# IMMINGHAM EASTERN RO-RO TERMINAL

Proposed Change Request Report

Document 10.3.11

November 2023

- 2.14 Figures 1 and 2 below show how the originally submitted scheme would be amended if this Proposed Change 1 is accepted.

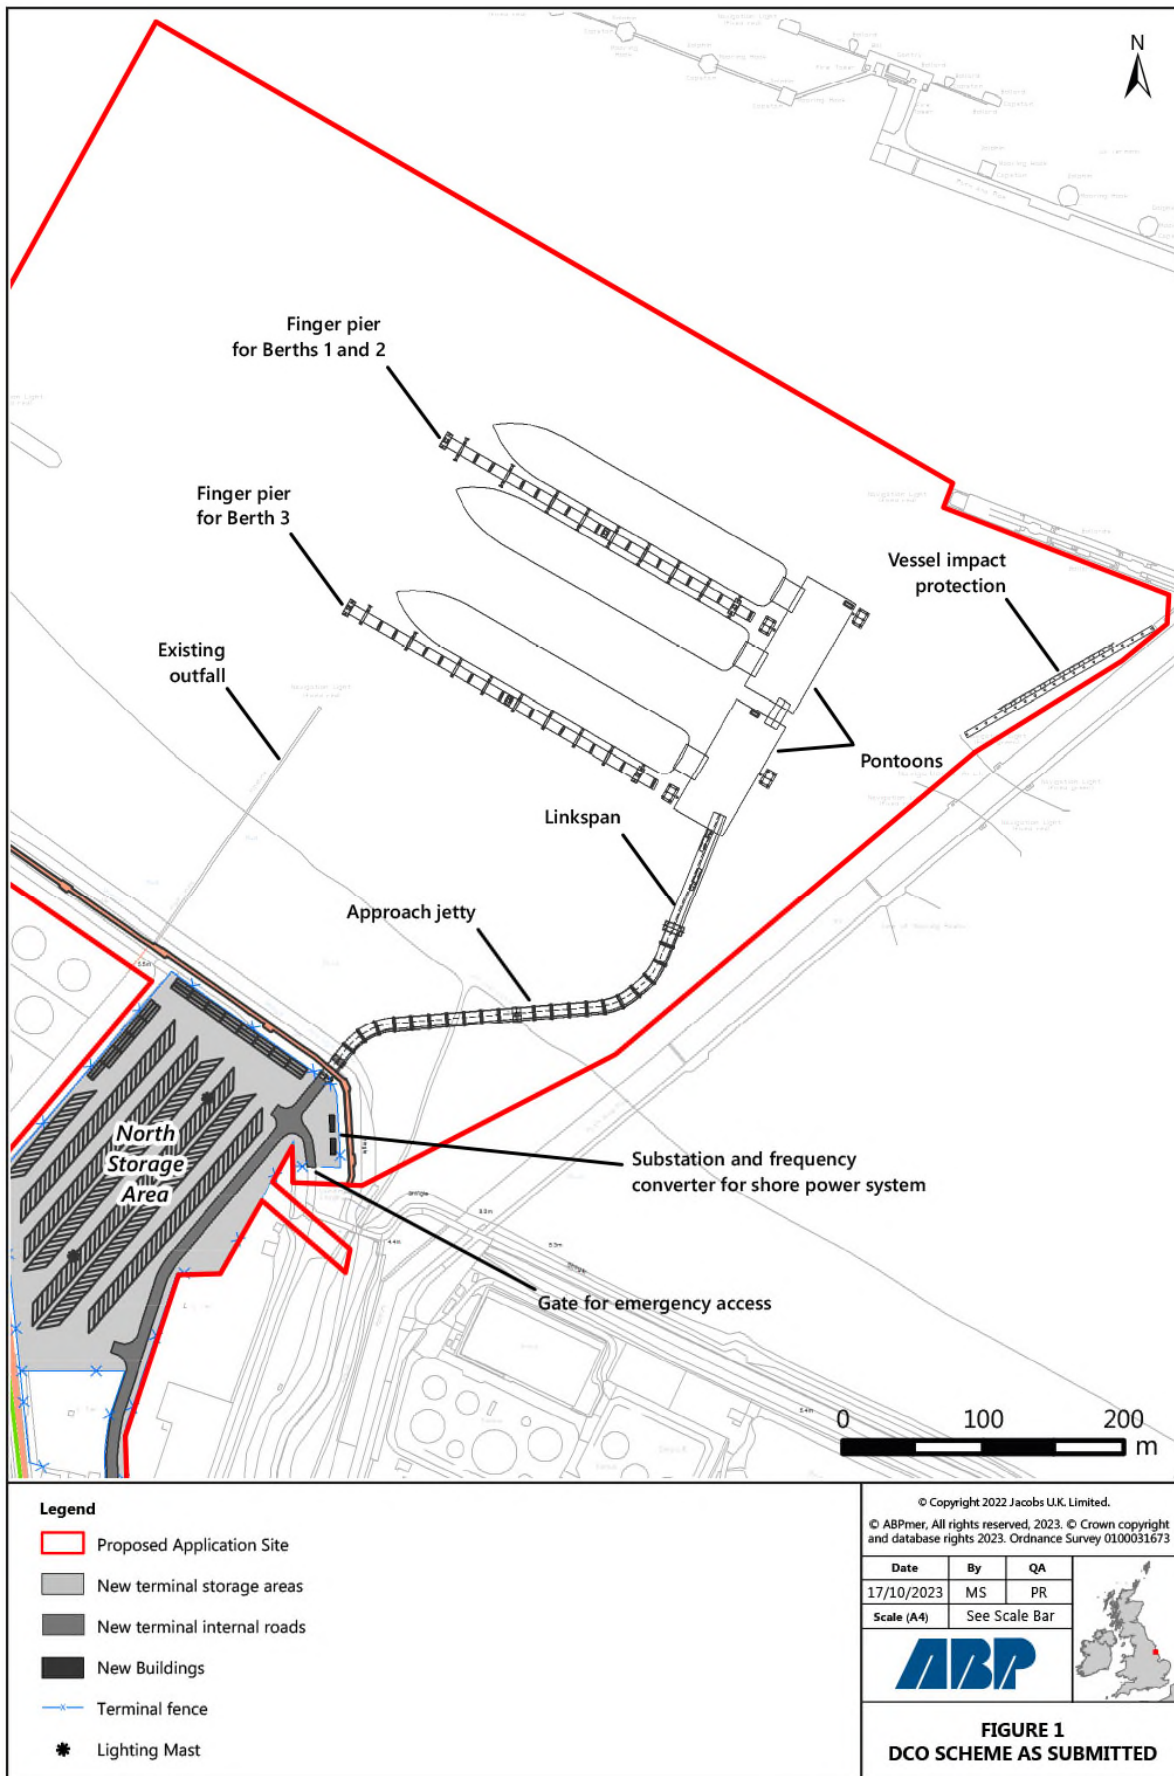
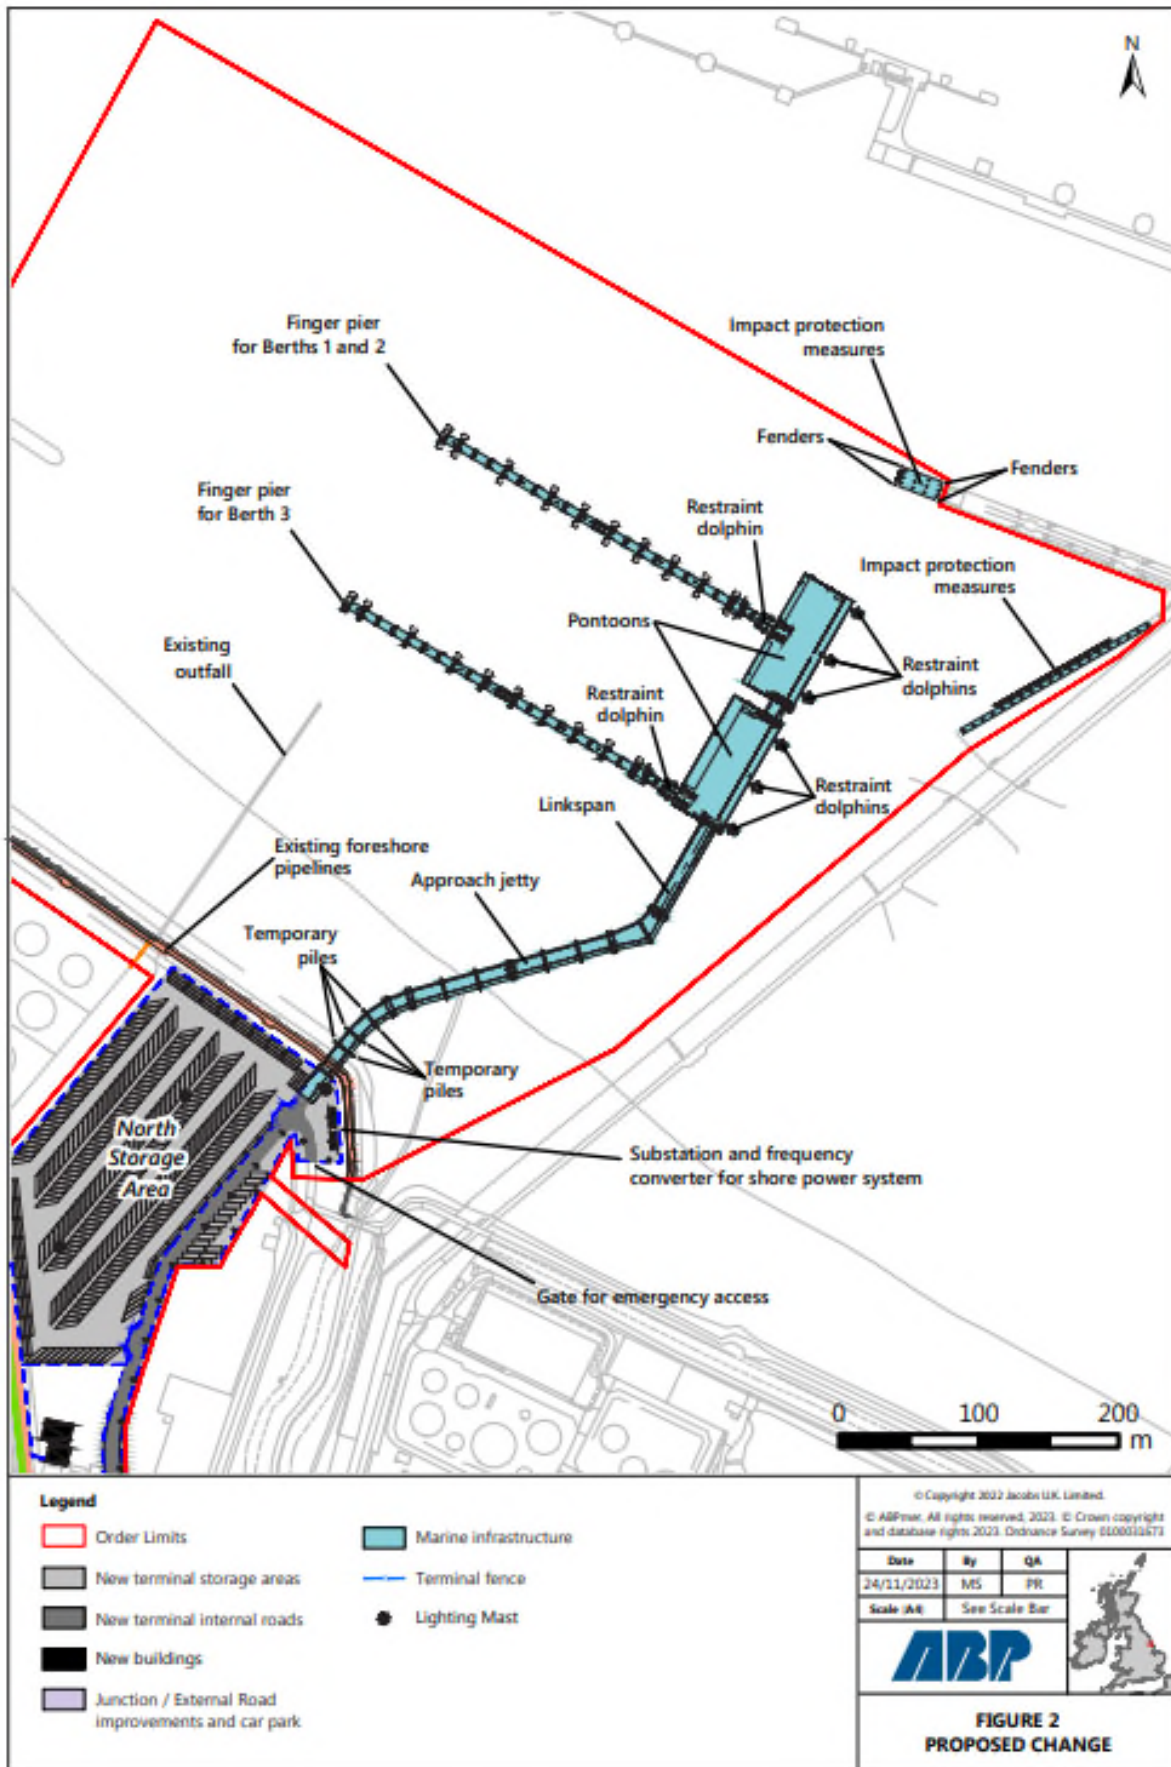
- ***Change 1: The Realignment of the Approach Jetty and Related Works to the Marine Infrastructure*** – the realigned approach jetty remains within the submitted limits of deviation but is moved further away from the IOT trunkway. As far as the construction of the jetty is concerned, there will be a reduction in the number of piles used which assists the sustainability of the Project and also the relocation of the piles which in terms of increased spacing will, to a small extent, assist roosting birds. In addition, certain works will be undertaken to strengthen the berthing infrastructure.

- 2.3 Proposed Change 1 involves works within the marine environment across and within the Humber Estuary SAC, SPA and Ramsar site. The works principally involve the realignment, effectively a straightening, of the approach jetty, within the submitted Order limits of deviation.

- 2.12 ***Finger pier adjustments*** – two additional piles to support bollards above, have been added to the Proposed Development's finger piers to improve mooring performance. The additional piling required has been assessed to identify whether there is likely to be a change to the conclusions on environmental impact set out in the ES. The conclusion is that any additional impact will be minimal – as detailed in the ES Addendum (document reference 10.3.8) at paragraphs 9.3.6 - 9.3.9.

- 2.13 ***Height of the Approach jetty*** – A further change which is being proposed is as a result of a need to raise the height of the approach jetty. This change in height is required for two reasons, namely –

2.22 Figures 3 and 4 below show how the originally submitted scheme would be amended if this Proposed Change 2 is accepted.

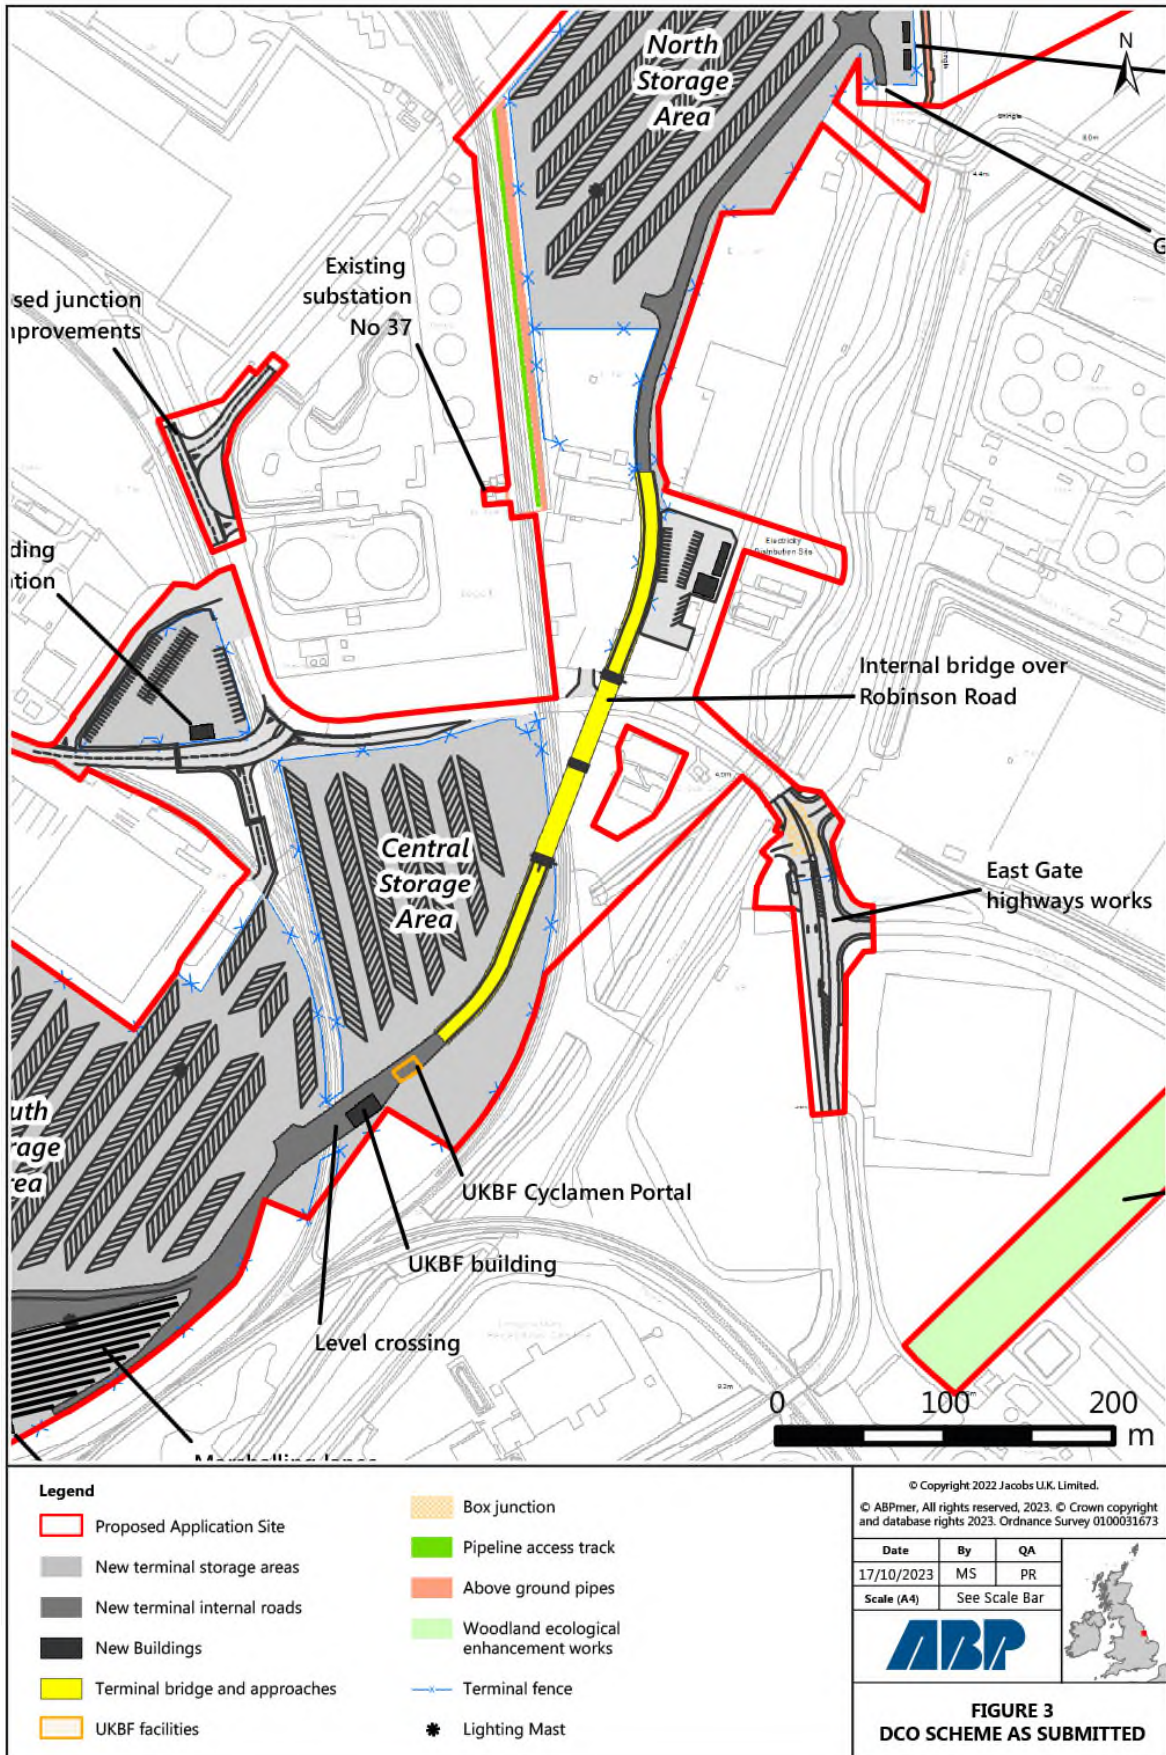
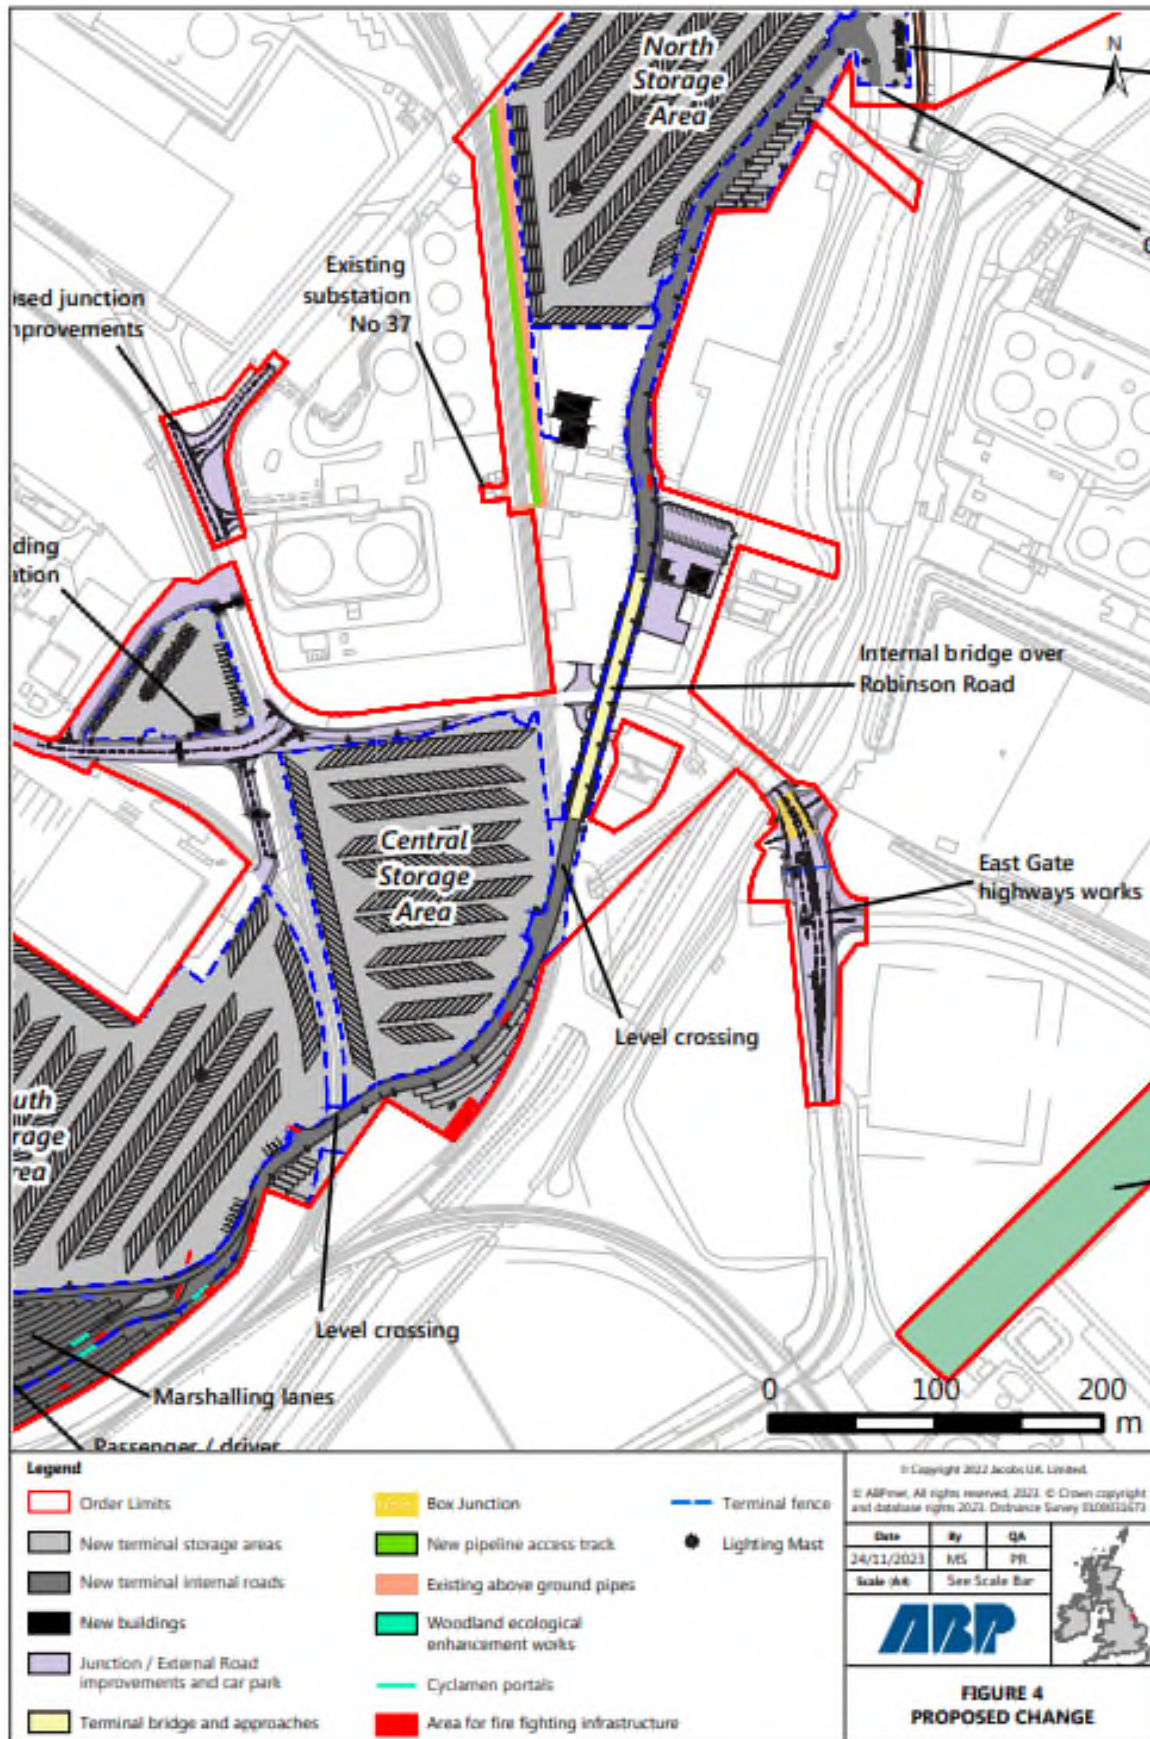
- ***Change 2: A Realignment and Shortening of the Length of the Internal Link Bridge and Consequential Works*** – between the Northern and Central Storage Areas. This will enable the optimisation of land in the Northern Storage Area for both the Applicant's tenant and sub-tenants as well as enabling a rationalisation and consequent increase in space within the Central Storage Area, albeit leading to a consequential amendment to the originally defined Limits of Deviation. The shortening in the length of the bridge will reduce the amount of construction materials required.

- 2.21 The change affects the originally submitted plans in that to bring the bridge down safely before ABP's internal railway line, it will be necessary to amend the originally identified limits of deviation, as shown on the substitute amended Works Plans (application document 2.3) submitted in support of the Changes Application.

**Sustainability** – The proposed change does, also have a sustainable environmental benefit, in that the proposed change reduces the length of the bridge from 116 metres to 86 metres leading to a reduction in the concrete deck, and consequently the materials required, by 400m<sup>3</sup> tonnes of concrete and 60 tonnes of reinforcement.
